SPECIFICATIONS AND DRAWINGS
HOUSING AUTHORITY OF THE CITY OF LUMBERTON: TURNER TERRACE
REPAIR OF FLOOD-DAMAGED UNITS
TWC # 3313-B 03

SUBJECT: ADDENDUM NO. 2

MAY 9, 2019

To the Plans and Specifications for:
Housing Authority of the City of Lumberton: Turner Terrace
Repair of Flood-Damaged Units

SHEET NO.
E104

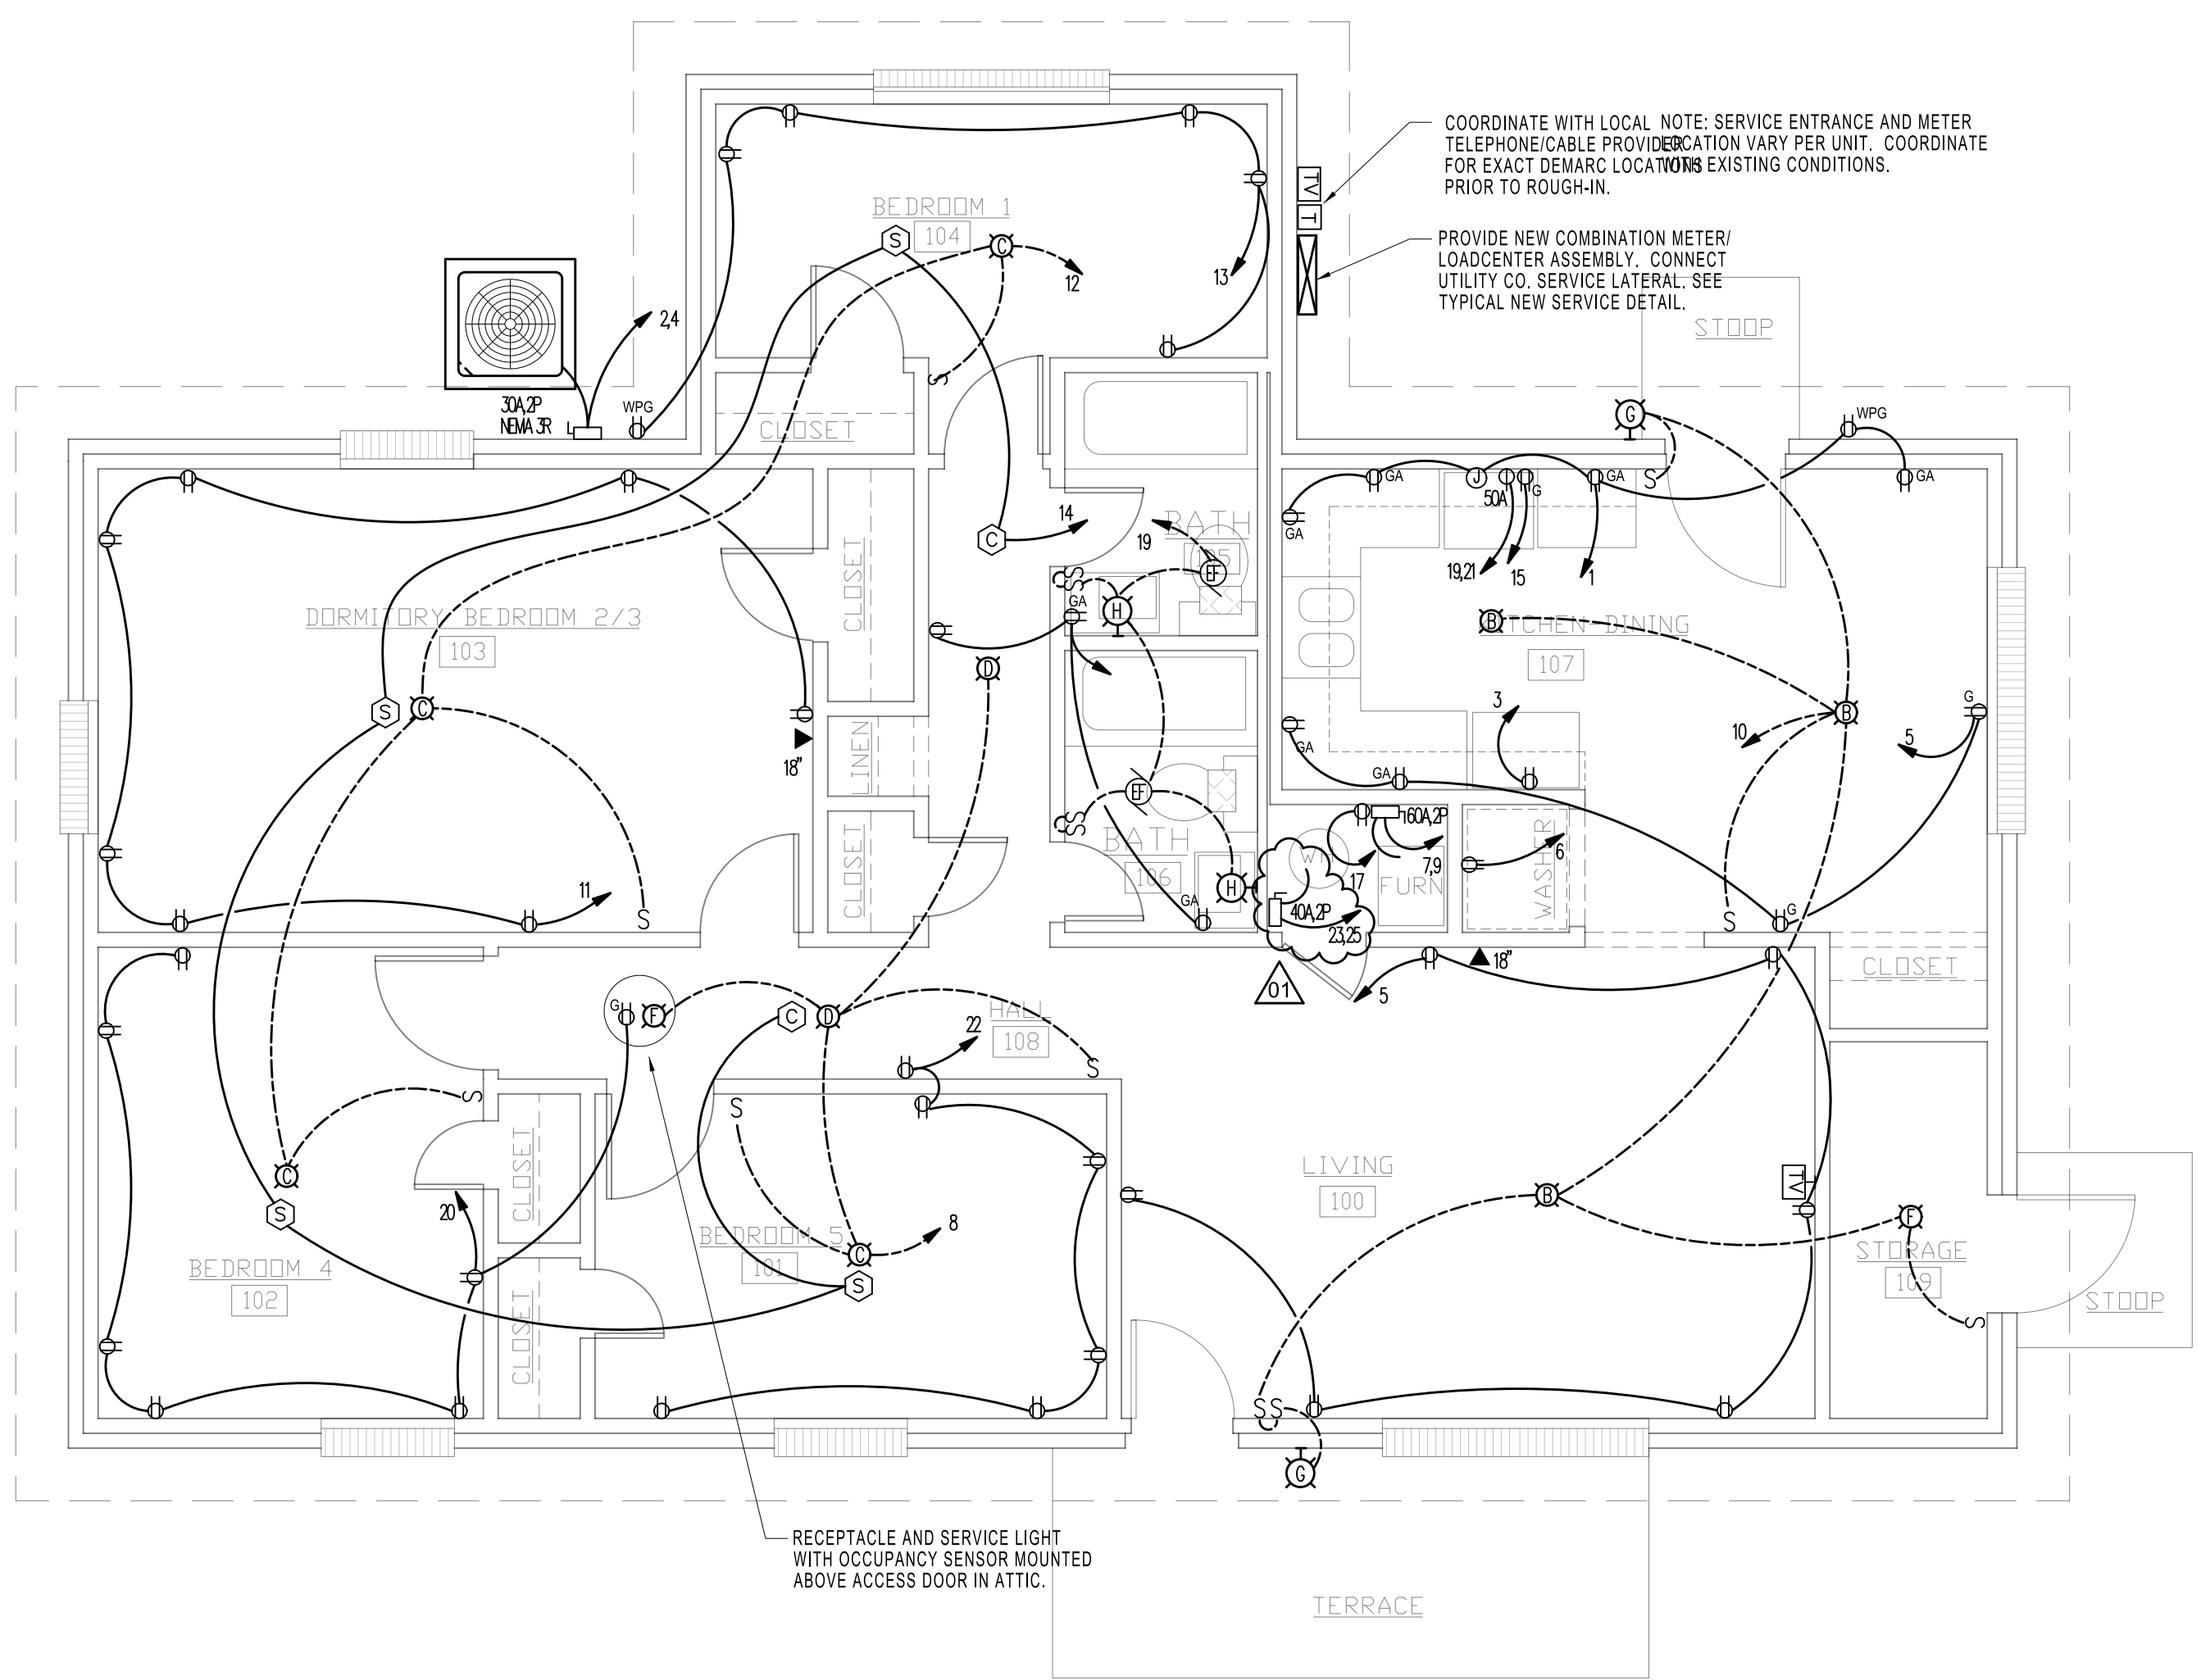
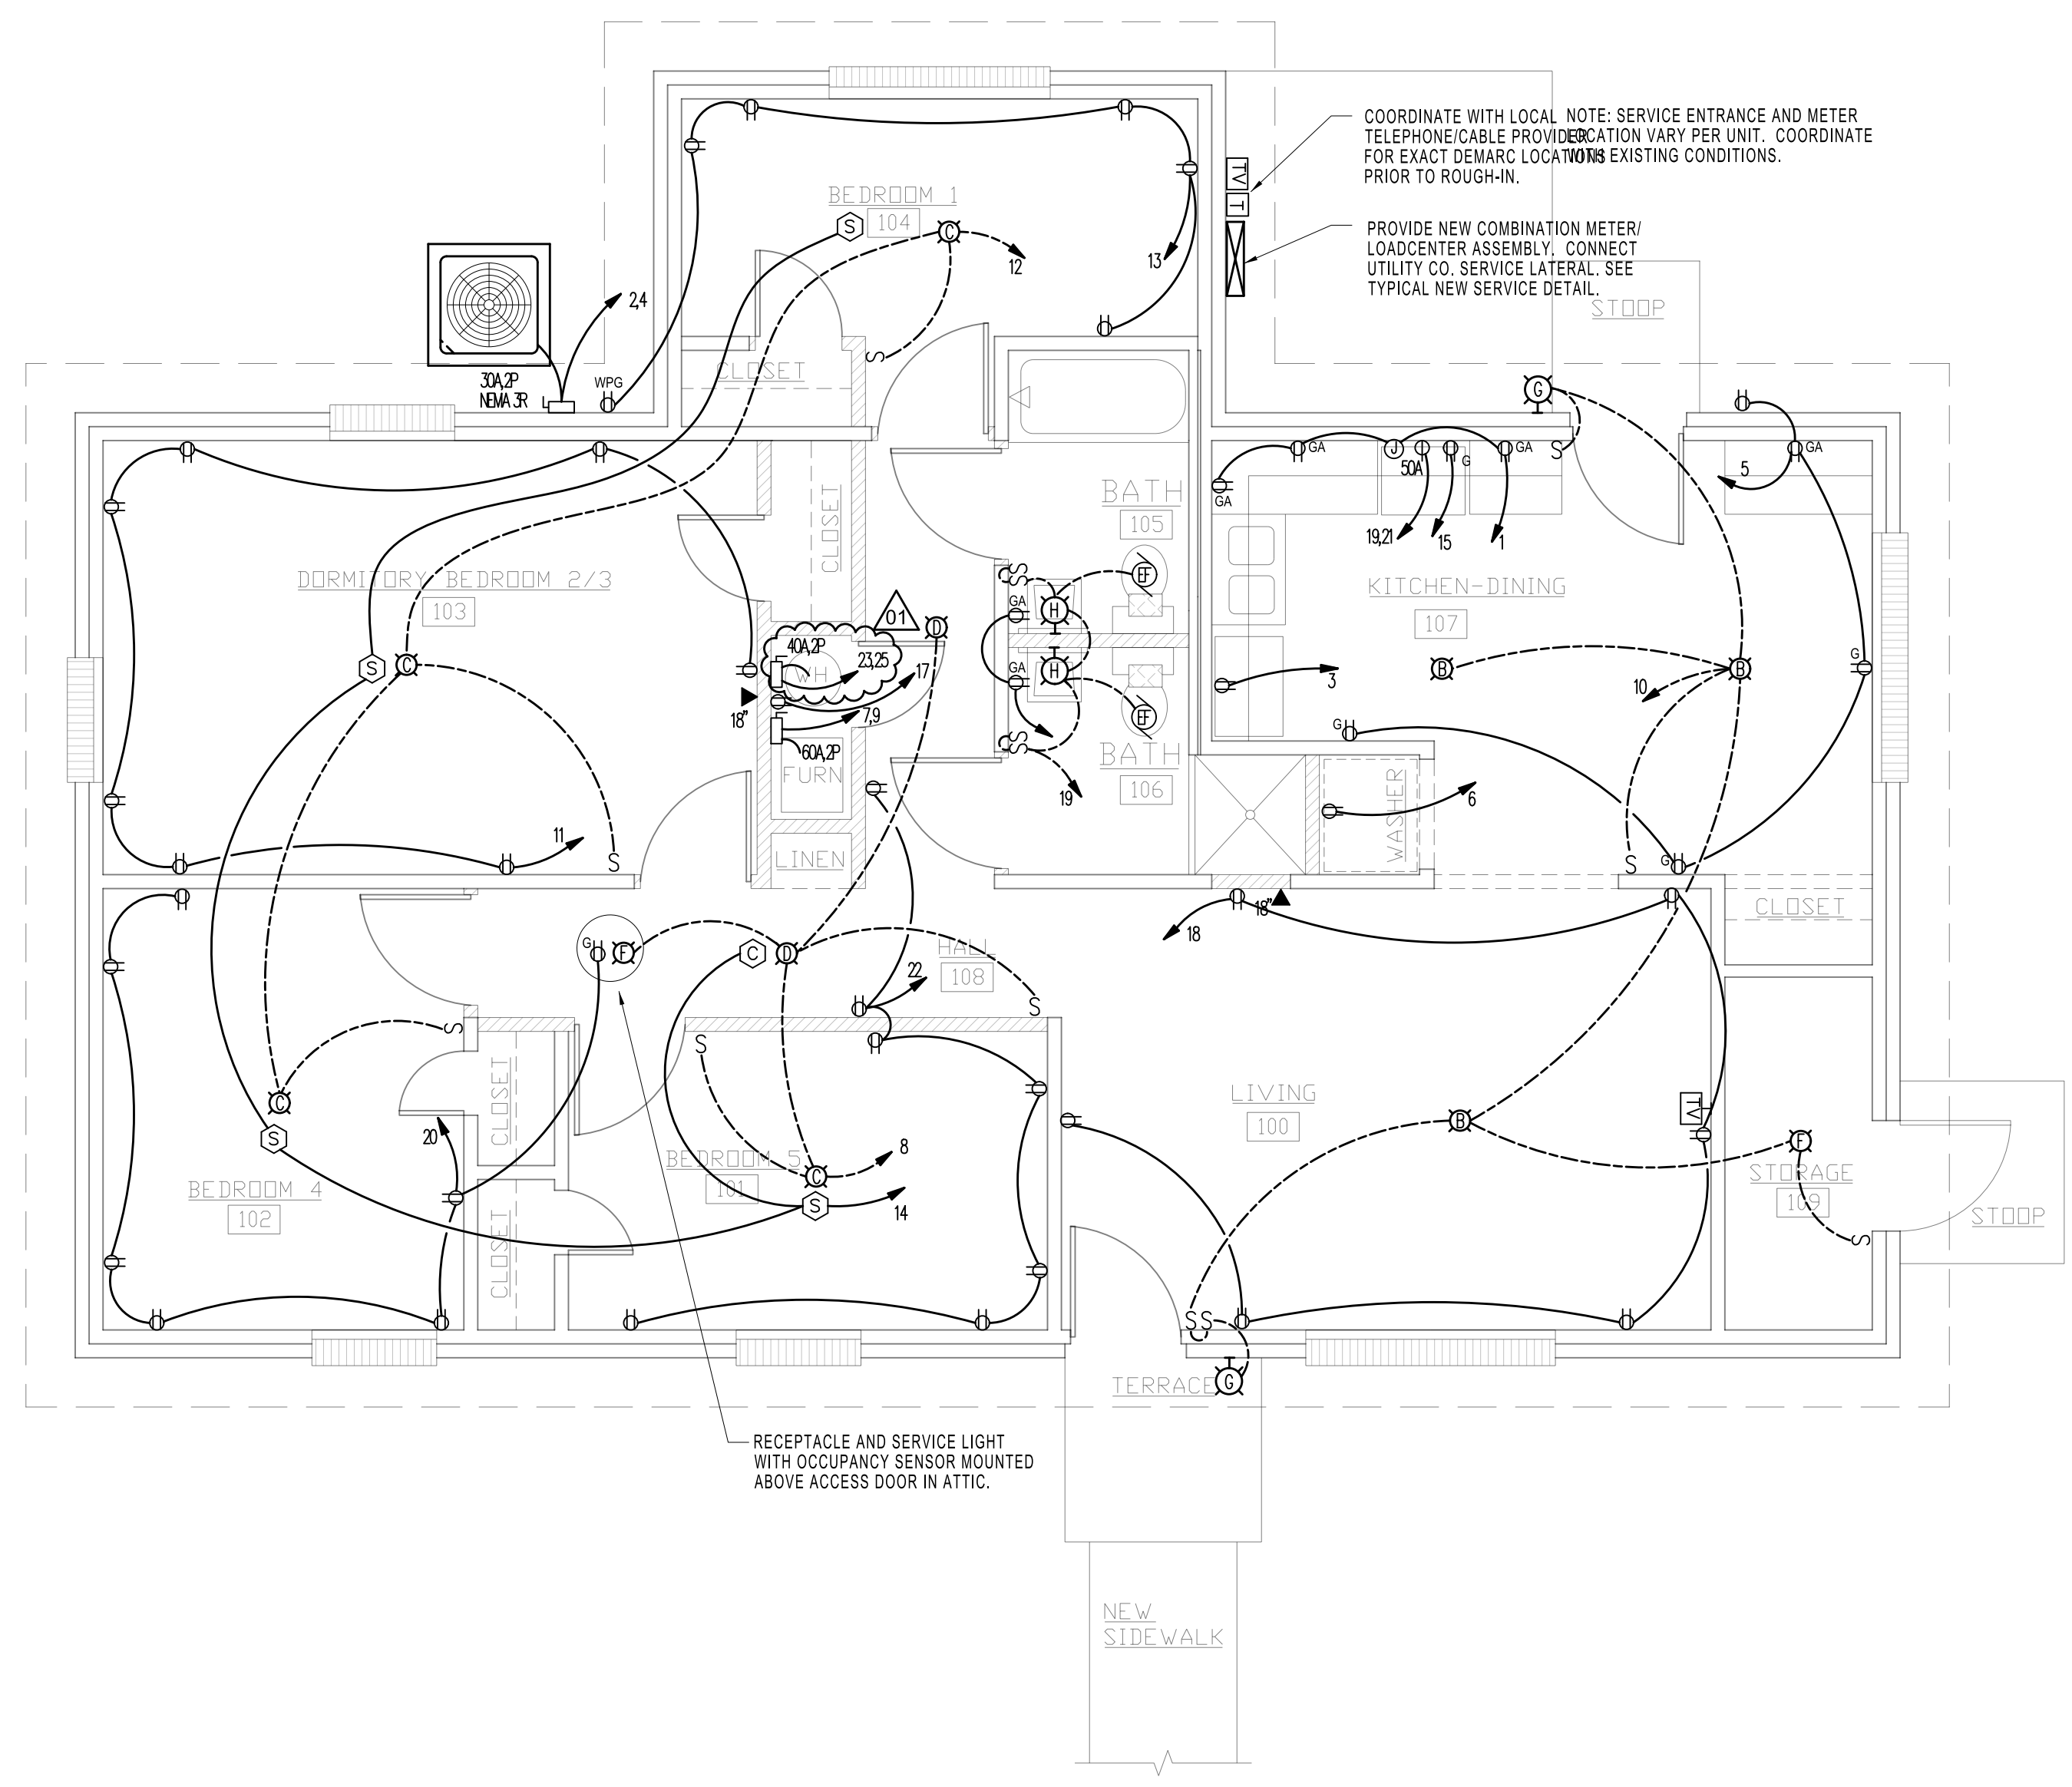
- b. 1/E104: Add circuit for electrical water heater.
 - c. 2/E104: Add circuit for electrical water heater.
11. Sheet E201
 - a. Replace with attached.
 - b. Panel schedules: Revise current rating.

3 NEW DUPLEX SERVICE DETAIL
E201 NO SCALE

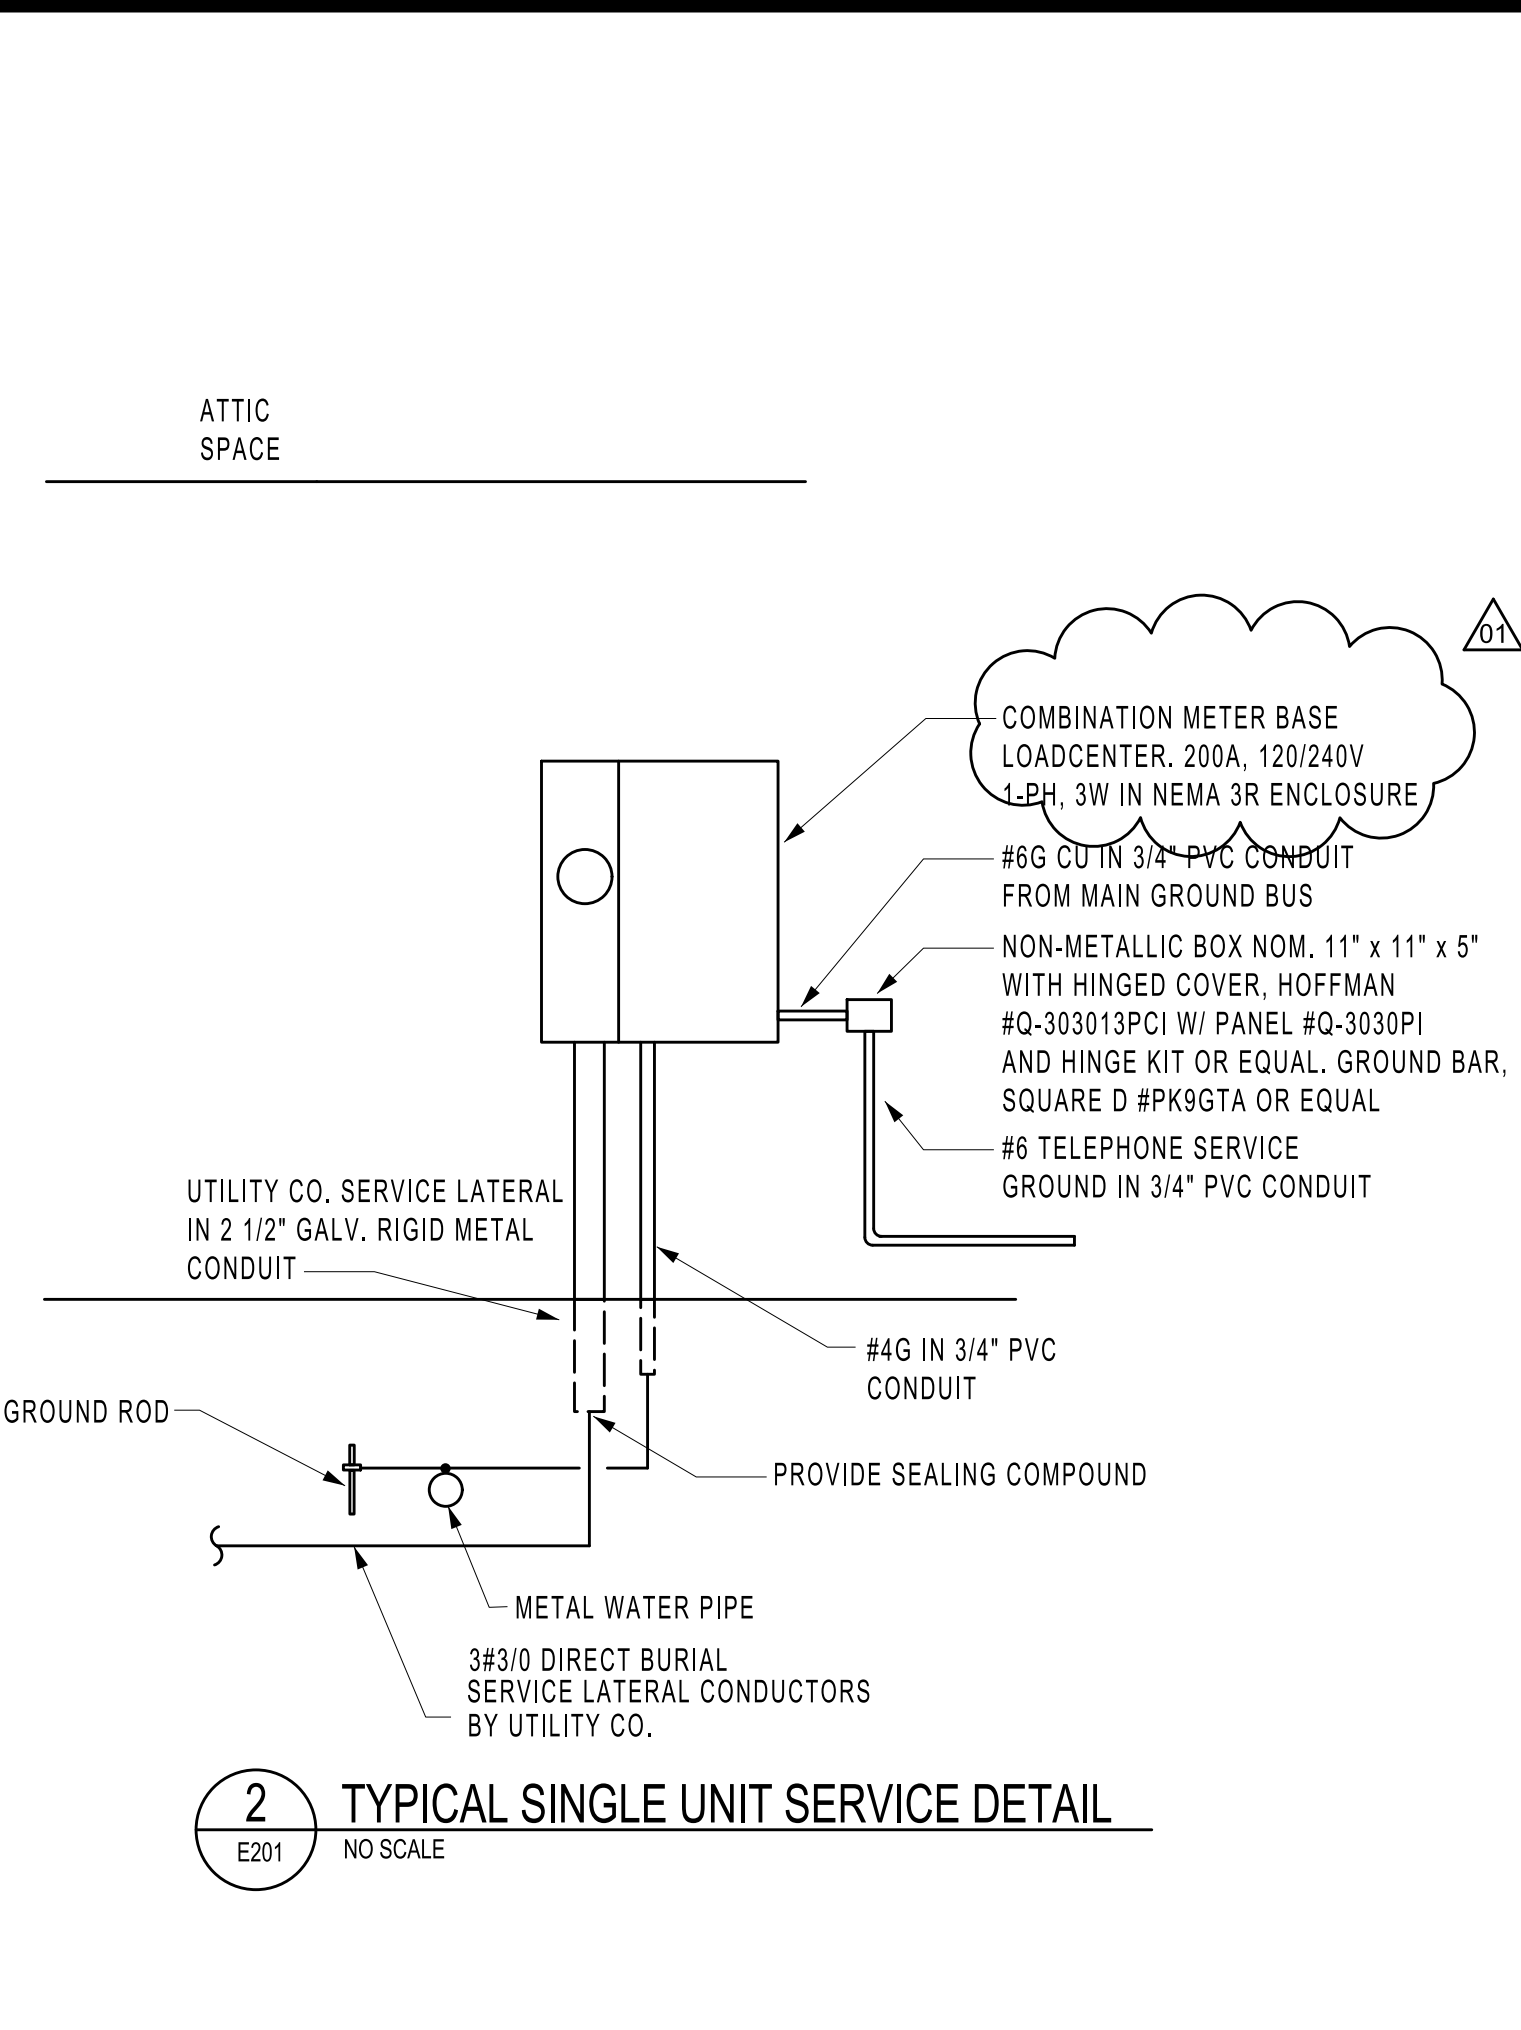
- c. Add circuits for electrical water heaters.
 - d. 2/E201: Revise note for service entrance equipment.
 - e. Add riser 3/E201.
 - f. Add riser 4/E201.
